MPC Paper No. A/K14/773A
For Consideration by
the Metro Planning Committee
on 18.10.2019

**APPLICATION FOR PERMISSION
UNDER SECTION 16 OF THE TOWN PLANNING ORDINANCE**

APPLICATION NO. A/K14/773

- Application** : Proposed Minor Relaxation of PR and BH Restrictions

SECTION

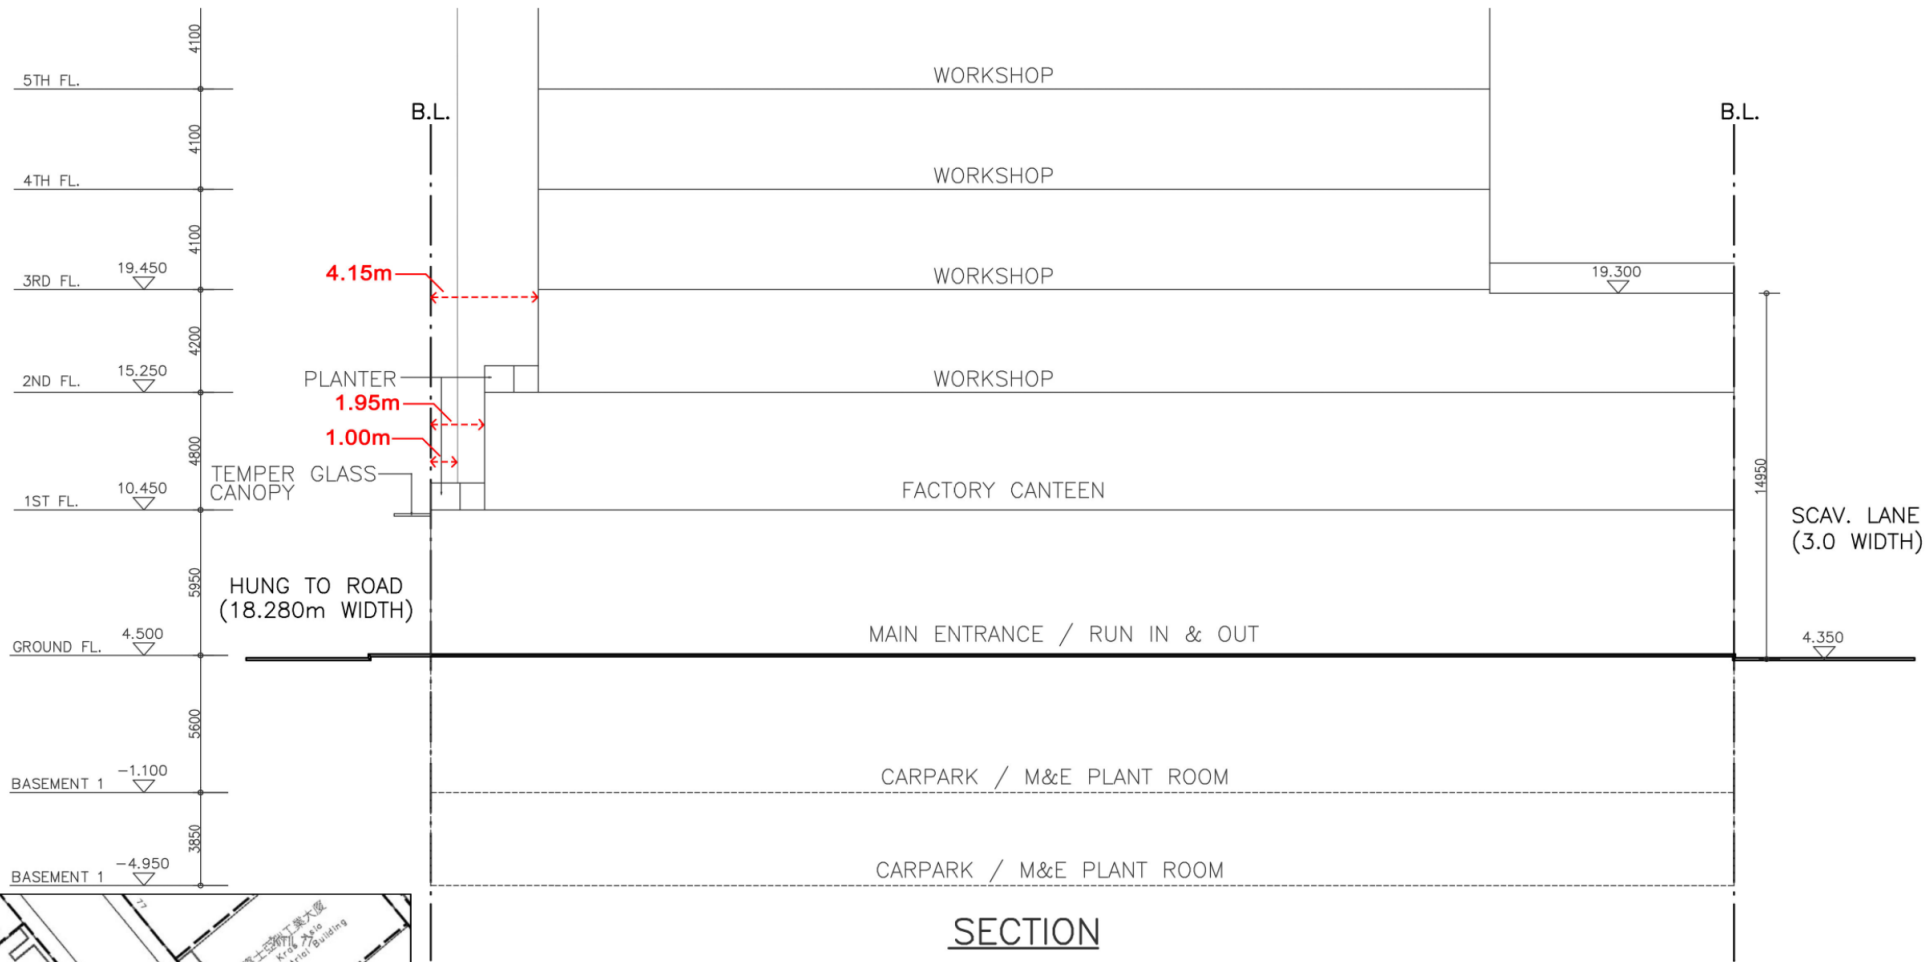
- 1.4 The main uses by floor of the proposed development and the floor-to-floor height under the Proposed Scheme (**Drawing A-6**) are summarized as follows:

- (c) Efforts have been made in minimizing the proposed increase in BH as far as practicable. The Proposed Scheme adopted a typical floor height of 4.1m (**Drawing A-6**) that allow flexibility for future operational needs of non-polluting industrial use. A 2-level basement parking is provided to further minimise the increase in BH. The proposed tower has been designed with SC of about 58% which is close to the maximum permissible under Building (Planning) Regulation (B(P)R), hence there is limited scope to further reduce the BH by enlarging the tower footprint. The Proposed Scheme incorporates a communal sky garden on 10/F with floor height of 5.95m that is the minimal requirement as set out in Code of Practice for Fire Safety in Building 2011 and Joint Practice Notes (JPNs) No. 1 and 2 that would generally enhance the visual quality with more greenery.

參考編號 REFERENCE No. A/K14/773	繪圖 DRAWING A - 7
---	-------------------------------

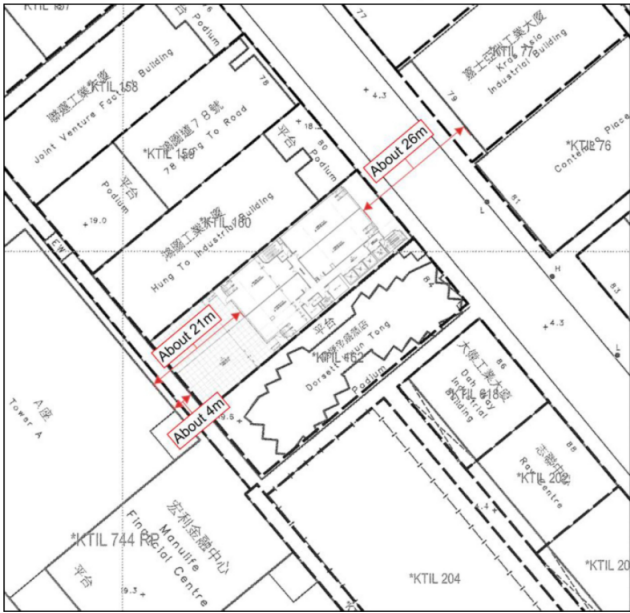
With the proposed 4.15m tower setback, about 26m separation with the buildings across Hung To Road would be reserved (**Drawing A-7**).

- (c) For the building separation between the Proposed Scheme and Manulife Financial Centre Tower (**Drawing A-7**), given the Site's surrounding context and its relatively small size, any potential improvement on the surrounding wind environment as a result of adjusting tower disposition will likely be minor.
- (d) The Site is located in an area of urban landscape character dominated by medium to high-rise industrial and commercial buildings. No existing tree is observed within the Site. Adverse landscape impact caused by the proposed development is not anticipated. In consideration of limited space within the Site, implementation of effective landscape treatment (particularly by means of tree planting) for bringing greenery contribution to the public realm seems not practicable. As such, he has no adverse comment on the application from landscape planning perspective.

繪圖
DRAWING
 A - 10

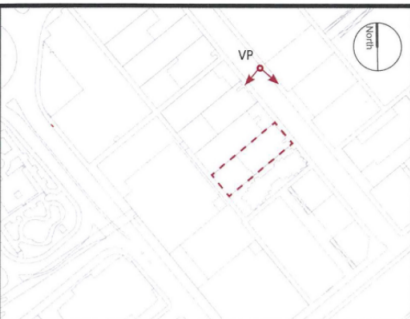
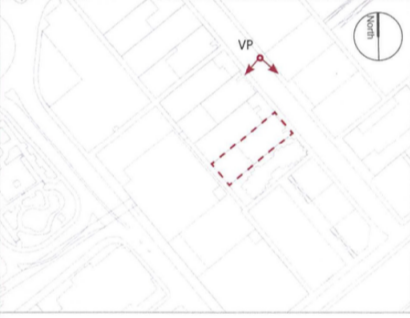
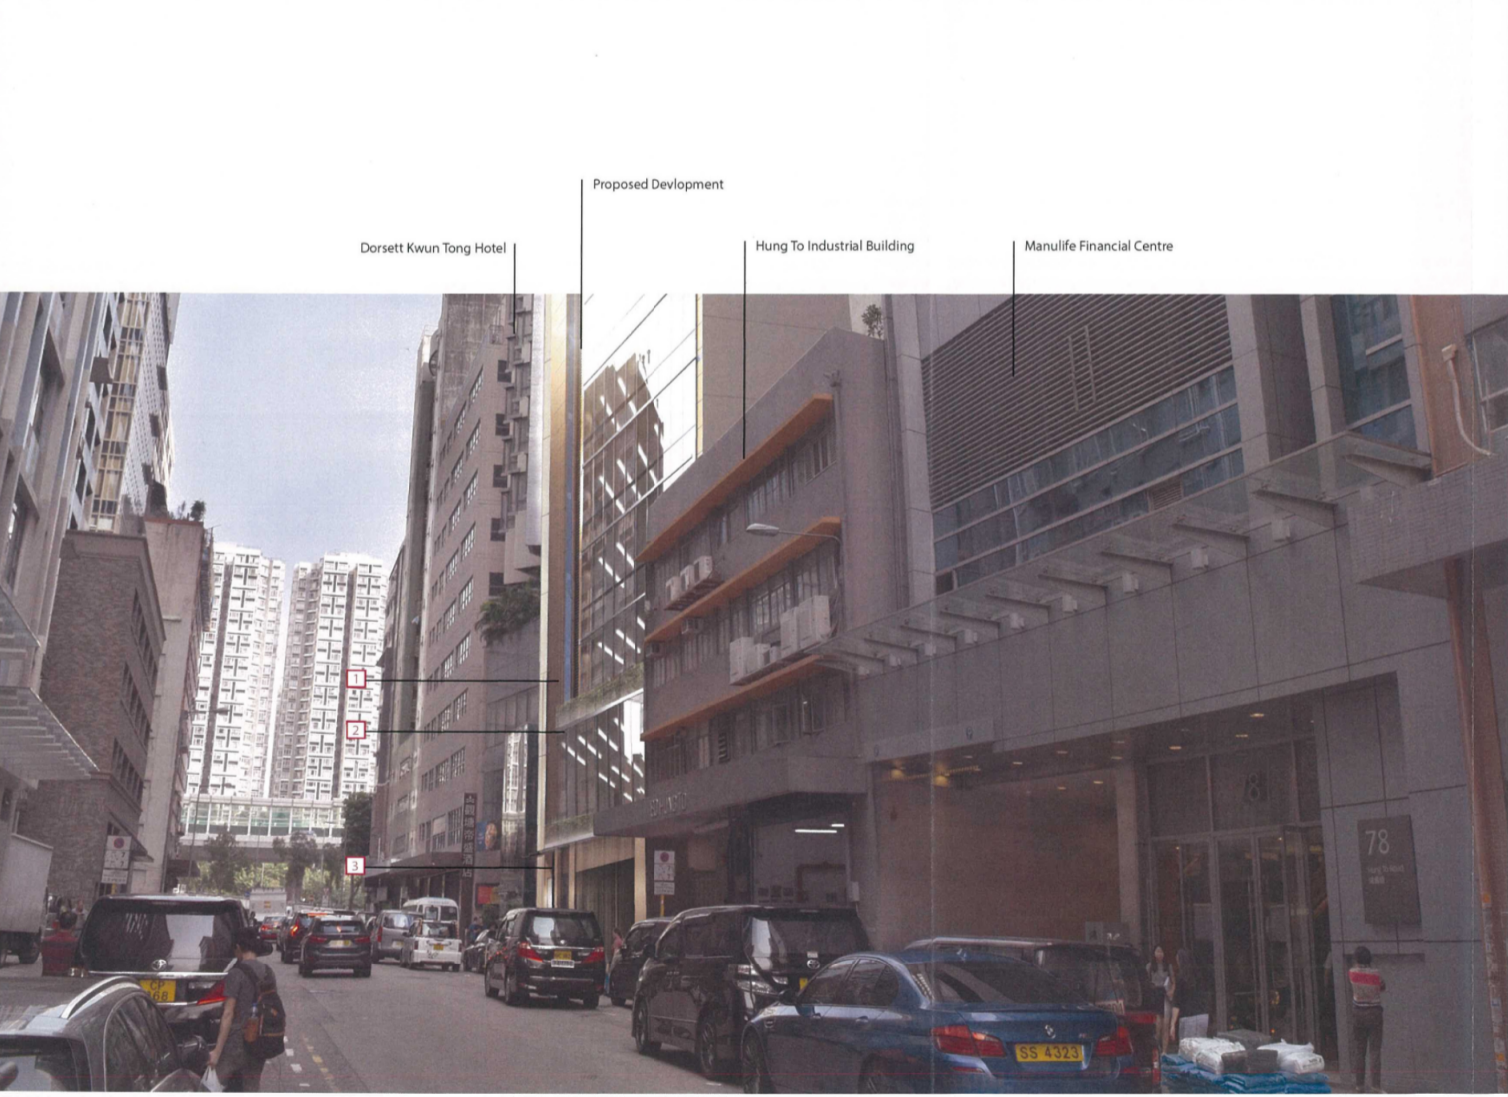
- (h) There is no setback requirement along this section of Hung To Road, the recently completed developments near the Site do not provide setback, piecemeal G/F setback for section within the Site (about 17m-wide) would not achieve any significant and effective improvement to pedestrian circulation. About 13.4m of street frontage will be occupied by the proposed vehicular access/main entrance and firefighting and rescue stairway, and the remaining 4m is reserved for other utilities (**Drawing A-2**). With the narrow street frontage, there is limited scope to provide soft landscape at pedestrian level/vertical greening on G/F frontage. A visually lightweight glass canopy structure is provided above the existing pedestrian pavement on Hung To Road that would replace the existing large concrete canopy. The glass canopy would offer protection from inclement weather while allowing sunlight to filter down the pedestrian level to enhance the comfort of pedestrian environment. Besides, proposed greenery at 1/F and 2/F visible from Hung To Road pedestrian level would be provided for enhancement to pedestrian environment (**Drawing A-10**).

- *providing better streetscape/good quality street level public urban space* – with the visible greenery features at 1/F & 2/F and glass canopy for all-weather protection to the pedestrian at G/F facing Hung To Road as set out in paragraphs 2(e) and (h) above (**Drawing A-10**);
